**PERMIT ID: 2012-65702**

Interior renovations for new restaurant 1st & 2nd floors (change of use for 2nd floor), including structural upgrades to beams, columns & wharf bents and 2nd floor exterior deck w/outside dining on both decks (internal demo permit #2012-10-5242)

#### Benjamin Wallace - RE: Poppy's Fish Shack permit 2012-65702

Copyright 2013, David Matero Architecture, LLC Response to Portland Fire Prevention Officer

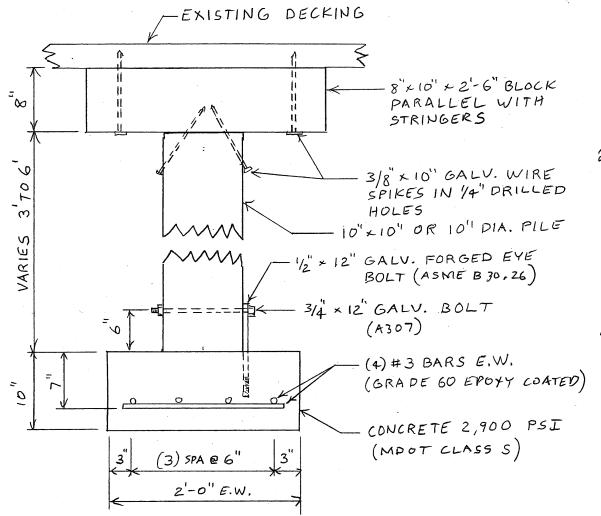
On Thursday 27 December 2012 I inspected the supports under 6 Custom House Wharf. Of the 76 timber piles and posts under the building, five require repair by the standard method of splicing in a new post and encasing the splice in concrete. This will maintain the first floor live load capacity of 100 psf.

I have Joe Leasure's letter dated 15 October 2012 and accompanying drawing S1 that details the proposed loading on existing and new columns supporting the second floor. The columns in bent 13 (the north wall) bear on a brick foundation wall and are adequate for the specified loading. Joe has specified to reuse two existing pipe columns and add four new HSS 4x4 structural tube columns. These six columns (including the two existing) require the installation of new 20 kip capacity concrete footings and timber columns per the attached sheet 1 of 2.

Joe has provided the column loading on the eight existing timber columns between bents 15 and 24. These columns bear on an 8x10 stringer (laid flat) between bents. In only one location is this stringer adequately supported for the proposed second floor loading. The other seven locations require this stringer to be reinforced with new 48 kip capacity concrete footings and timber columns per the attached sheet 2 of 2.

These new 20 kip and 48 kip capacity footings will relieve the existing supports under the first floor from the second floor loading. I will observe the installation of these additional supports to ensure compliance with the plans.

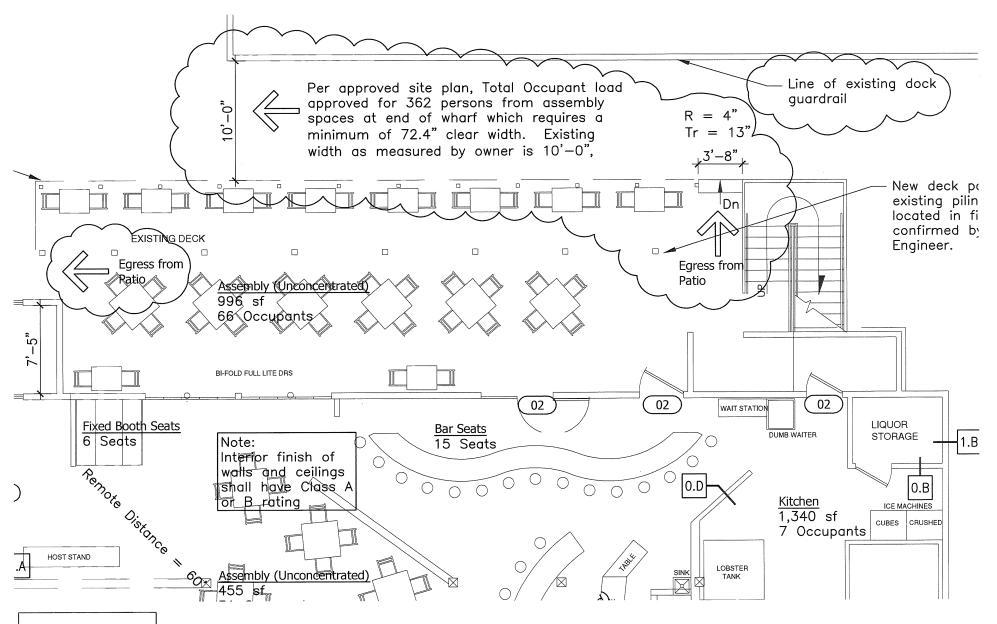
- I need an updated plan for the patio area showing the two required remote exits off from the patio and also how the required occupant load from the adjacent spaces on the South side of this one are being accommodated as shown on the attached egress plan for the wharf. Please also indicate if the exit discharges from within the building and from the patio are level or not level, and if not how the transitions are being made.

The wharf egress is currently 10'0" from the wharf railing to the existing patio, as measured by the owner. This egress path will remain, therefore the minimum dimension (72.4") to maintain safe egress from the future assembly spaces at the end of the wharf will remain. Refer to ASK.05 for this information, as well as the two means of egress from the roped off patio area.

ASK.01

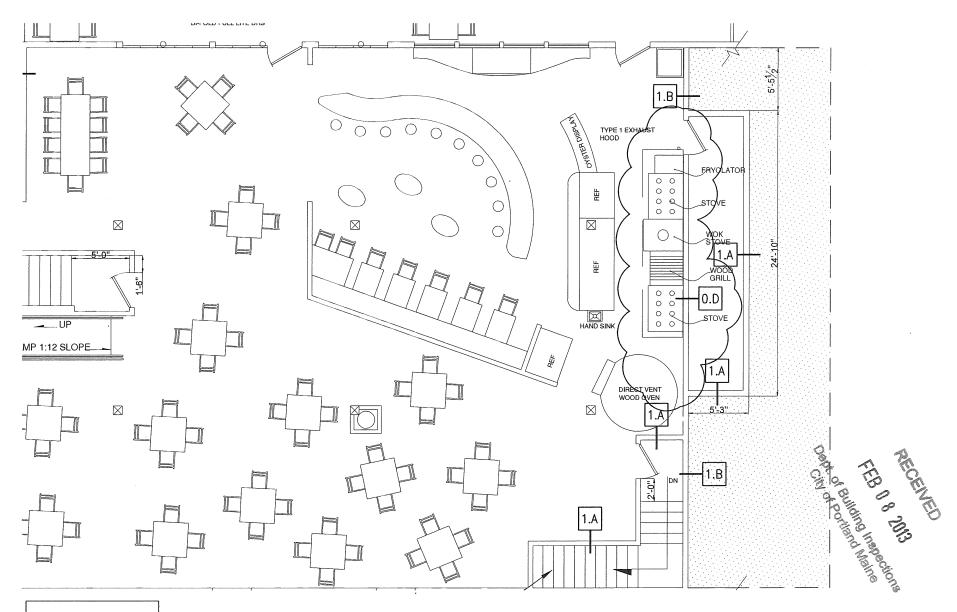
- 5. Another issue that we did not discuss, but that is important none the less, is where the kitchen hood exhaust ductwork is running. If it penetrates the floor it needs to be in a shaft complying with NFPA 96:7.6. Please let me know if the duct will be run out through the wall and then to the roof or amend the plans to show the rated shaft(s). Who ever puts in for the commercial hood permit will have to have hood and duct plans stamped by an engineer.

Non-combustible partitions have been added at kitchen hood locations to create a zero-clearance hood attachment. The kitchen hood and duct subcontractor is still required to submit drawings for approval once they have been retained. It will be their responsibility to confirm that the hood and duct assembly and its attachment meet NFPA 96. Refer to ASK.01, 02, and 03
